Access Compliance Report

Public Rights-of-Way

Intersection ID: 43079	Main Street: SUMTER_AV	Cross Street: WALNUT_AV	Location:	N
ADA ID: 48D69204D6FC	Ramp Type: PerpDiag	Initial Pass/Fail: Fail	Overall Compliance: No	Severity Score: 67.5

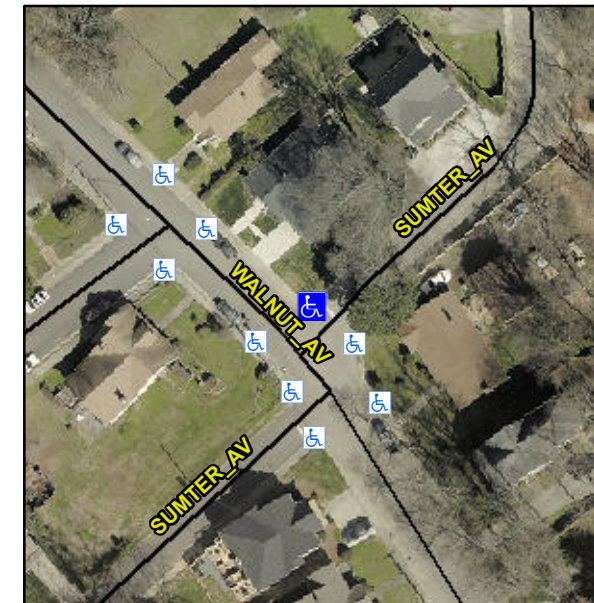
Not Found, R304.5.1, R304.2.2, R304.5.3

Compliance	Description	Data	Compliance	Description	Data
N/A	Ramp Length (in)	43.0	No	Ramp Slope (%)	13.9
No	Ramp Width (in)	34.0	No	Ramp XSlope (%)	7.0
N/A	Flare Type LT	N/A	N/A	Flare Type RT	N/A
N/A	Flare Slope LT (%)	N/A	N/A	Flare Slope RT (%)	N/A
N/A	Flare Traversable LT?	N/A	N/A	Flare Traversable RT?	N/A
N/A	Landing Length (in)	N/A	N/A	DWS Provided?	N/A
N/A	Landing Width (in)	N/A	N/A	DWS Contrast?	N/A
N/A	Landing Slope (%)	N/A	N/A	DWS Length (in)	N/A
N/A	Landing X Slope (%)	N/A	N/A	DWS Full Width?	N/A
N/A	Landing Curb? (Y/N)	N/A	N/A	DWS Offset (in)	N/A
N/A	Shared Landing?	N/A			
N/A	Gutter Ponding?	N/A	N/A	Gutter Slope (%)	N/A
N/A	Gutter Lip Ht (in)	N/A	N/A	Gutter X Slope (%)	N/A
N/A	Painted X Walk1?	No	N/A	Painted X Walk2?	No
	X Walk 1 Direction	To SW		X Walk 2 Direction	To SE
N/A	X Walk 1 Width (in)	N/A	N/A	X Walk 2 Width (in)	N/A
	X Walk 1 Slope (%)	4.7		X Walk 2 Slope (%)	2.5
	X Walk 1 X Slope (%)	6.3		X Walk 2 X Slope (%)	4.2

Remove & Replace Curb Ramp With Two New Directional Ramps or Equivalent.
